Cosmetic Checks

Safety Checks - Bumpers

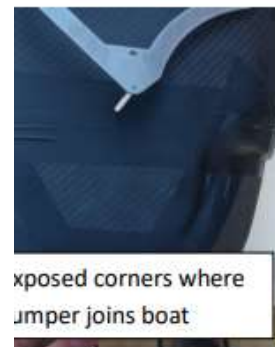
FAIL- loose edges
and pieces missing

FAIL- pieces missing

FAIL- loose edges
and pieces missing

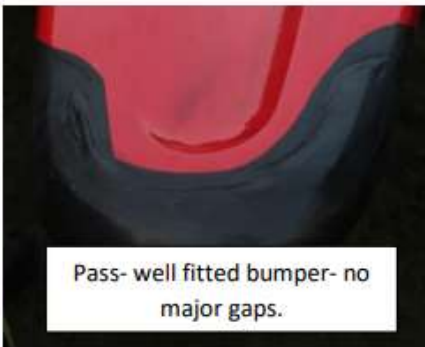
FAIL- exposed corners where
bumper joins boat

FAIL- too thin

FAIL- full tape wrap
not allowed
